**IEEE P802.18**  
**Radio Regulatory Technical Advisory Group (RR-TAG)**

Proposed Response to China MIIT Consultation on “Ultra-Wideband  
(UWB) Equipment Radio Management Regulations”

Date: 2023-01-25

**Figure 1: Comparison of the power spectrum density mask between the proposed regulation of China MIIT (i.e., “Proposed mask”) and the requirements defined in IEEE Std 802.15.4-2020 [1] for IEEE HRP UWB PHY channels 8 and 10 (i.e., “ch8” and “ch10”).**

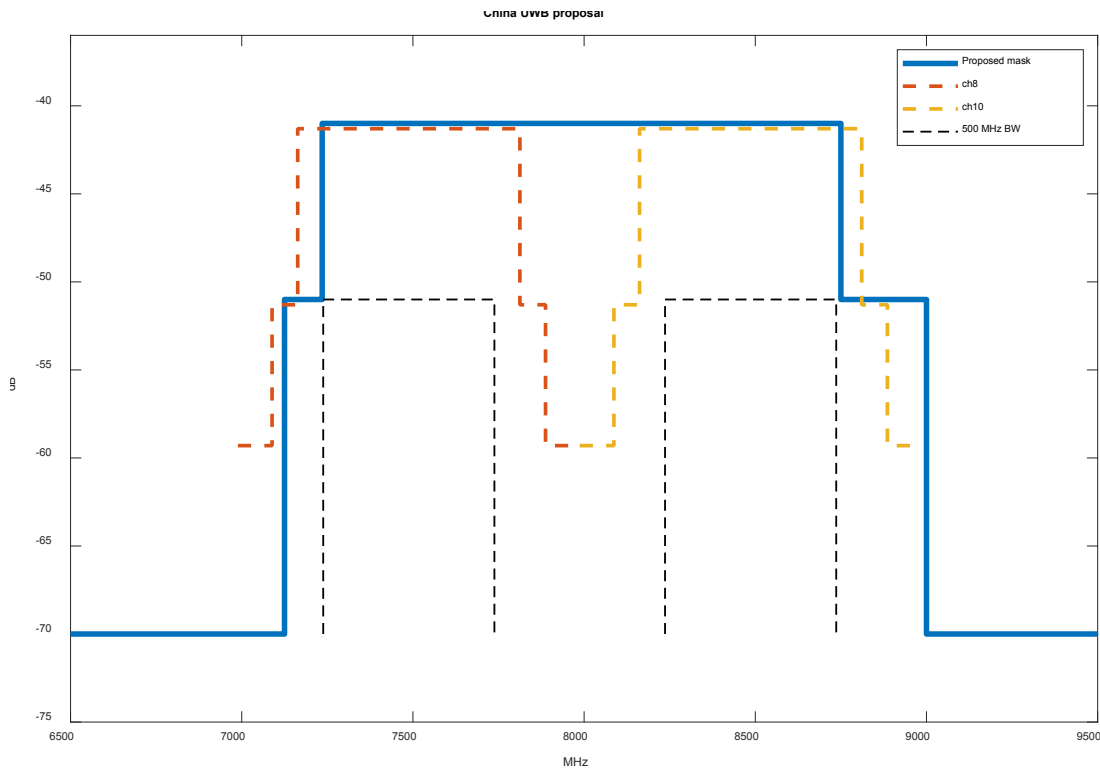
Figure 1 shows the power spectral density masks between the proposed regulation and those defined in [1] for IEEE HRP UWB PHY channels 8 and 10. Note that Channel 9 is left out intentionally to improve the clarity of the figure.

Figure 1 illustrates two issues with the proposed power spectrum density mask with respect to use of devices implementing IEEE Std 802.15.4-2020. First, the power spectrum density mask defined in IEEE Std 802.15.4-2020 does not fit inside the proposed limits. Secondly, the -10 dB minimum bandwidth is defined to be 500 MHz without any extra spectrum to account for the roll-off. The figure shows that meeting the minimum bandwidth requirement (staying above the dotted black line of “500 MHz BW”) and, at the same time, staying within the proposed emission limits (under blue line of “Proposed mask”) using the UWB channels defined by [1], is impossible with a practical implementation.

Given the center frequency of the IEEE HRP UWB PHY channel 5 is equal to 6489.6 MHz, the European rules define a frequency separation of 489.6 MHz from the center frequency to the band edge with -70 dBm/MHz limit. To enable use of IEEE HRP UWB PHY channel 8 with the center frequency of 7488 MHz in China, the corresponding separation for channel 8 would require the lower -70 dBm/MHz band edge not to be higher than 6998 MHz. It is worth noticing that the -51 dBm/MHz limit does not exist in [6]. If a -51 dBm/MHz limit is considered necessary, IEEE 802 LMSC suggests MIIT to consider the spectrum mask defined in the IEEE Std 802.15.4-2020 and set the -51 dBm/MHz limit at 7163 MHz or below.

Similar expansion of the available band would be needed for the upper UWB band limit to enable IEEE HRP UWB PHY channel 10 with the center frequency of 8486.4 MHz, where a -70 dBm/MHz limit would be set to 8976 MHz or above, and the possible -51 dB/MHz limit at or above 8810 MHz.

Table 2 summarizes example emission limits that allow the use of IEEE HRP UWB PHY channels 8, 9, and 10 in China.

Frequency range	EIRP limit
Below 6998 MHz	-70 dBm/MHz
6998 MHz – 7163 MHz	-51 dBm/MHz
7163 MHz – 8810 MHz	-41 dBm/MHz
8810 MHz – 8976 MHz	-51 dBm/MHz
Above 8976 MHz	-70 dBm/MHz

**Figure 2: Power spectrum density of the IEEE HRP UWB PHY channel 5 with center frequency of 6489.6 MHz (i.e., “ch5”) and the European band edge limits at 6 GHz (i.e., “Europe”)**

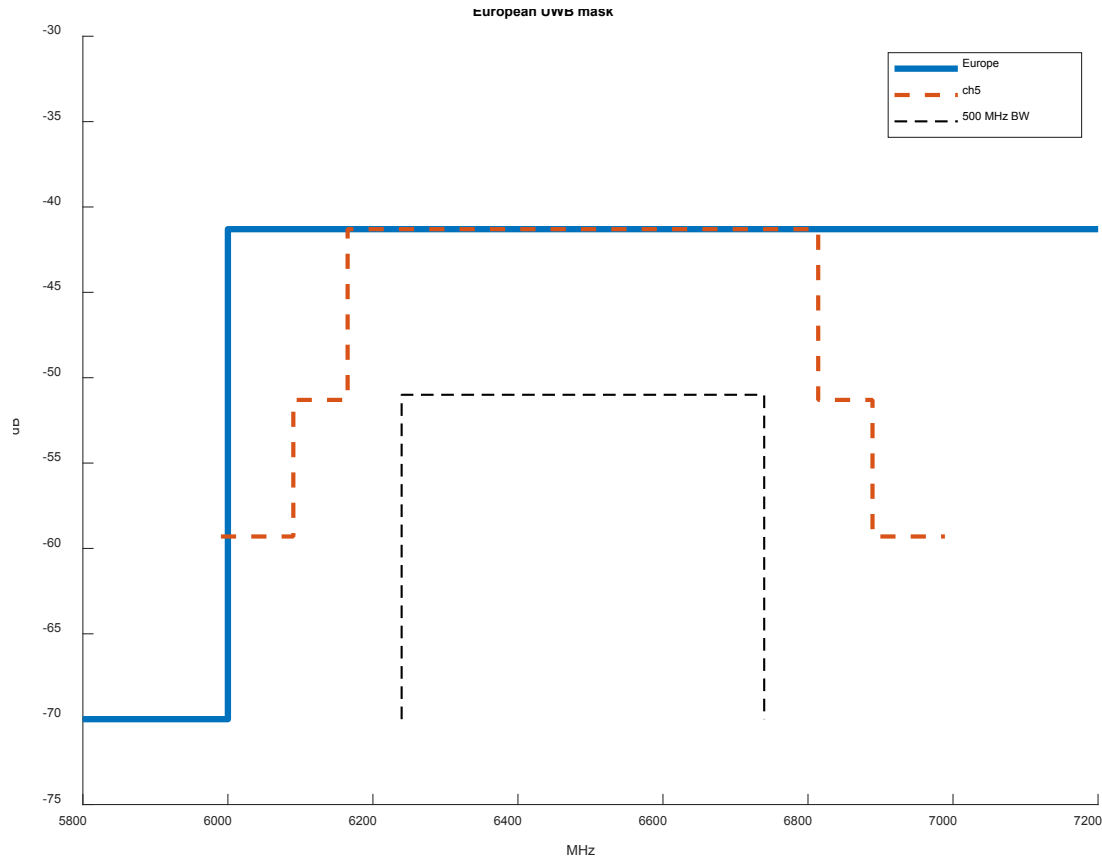
For comparison, Figure 2 shows the power spectral density mask of channel 5 and the existing European regulatory emission limits [4] at the band edge. This could be used as a reference for possible limits. The European limit at 6 GHz is not very relaxed by any means, but it does allow a feasible implementation. The 500 MHz minimum bandwidth limit is presented in the figure for reference, but it is not a requirement in Europe.
